REDLINE REVISION NO. 1 MARCH 2012
David Bane 3/15/12
 TEBD APPROVAL SHA NO. XX6475185

SHA STATE OF MARYLAND
 DEPARTMENT OF TRANSPORTATION
 STATE HIGHWAY ADMINISTRATION
 OFFICE OF TRAFFIC & SAFETY
 TRAFFIC ENGINEERING DESIGN DIVISION
 MD 174 (QUARTERFIELD ROAD) AT
 PAMELA ROAD /LANDMARK DRIVE
 HANOVER, MARYLAND

SIGNALIZATION PLAN SHEET

TS NO. 4721A DRAWING SG-01 OF 02 SHEET NO. 01 OF 02

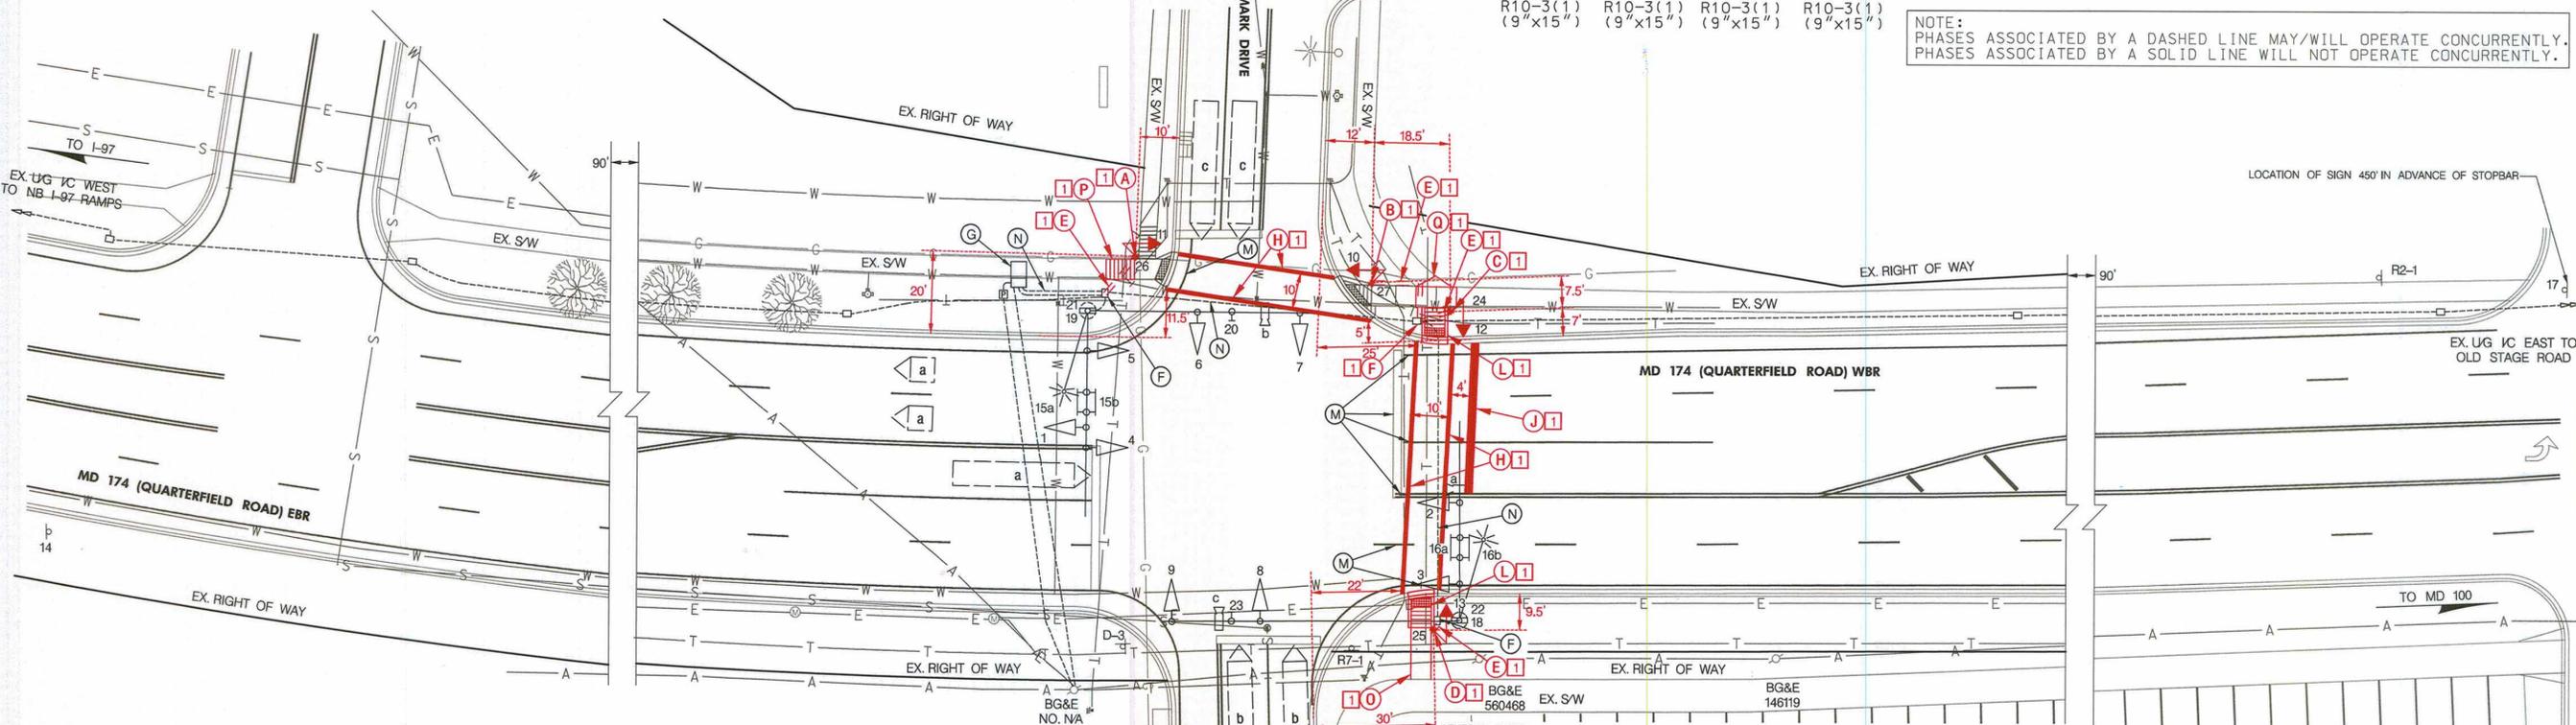
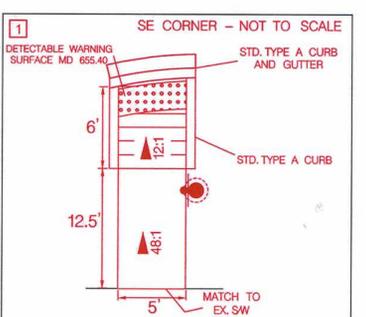
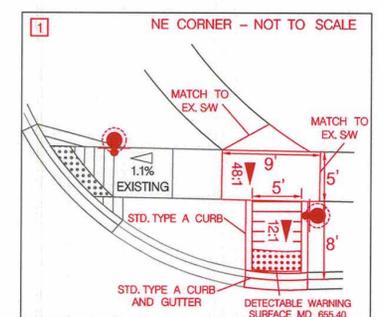
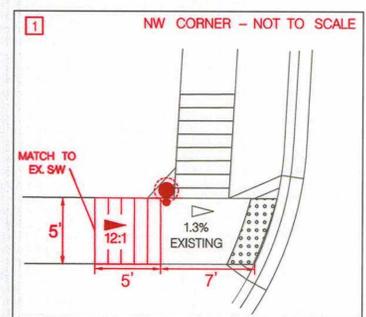
APPROVALS	REVISIONS
TEAM LEADER ASST. DIR. CHIEF DIVISION CHIEF OFFICE DIRECTOR	2. INSTALL APSPCS ALONG NORTH & EAST LEGS. SHA# X09475185 TMS# K049 12-30-2011 STV MCG
